Product / Process Change Notification (PCN)

PCN Number: PCN_IndCMBHC_20240503

Affected Series: WE-CMB HC

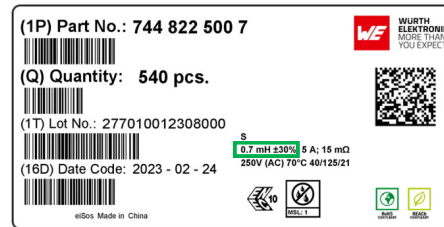
Due to internal standardisation, Würth Elektronik will change the packaging label.
 There will be no change in form, fit, function, quality or reliability of the product.

The international standard IEC 60938-2 is now requiring to print the inductance tolerance on the packaging label:

The current label doesn't show any inductance tolerance

The inductance value will be shown with tolerance
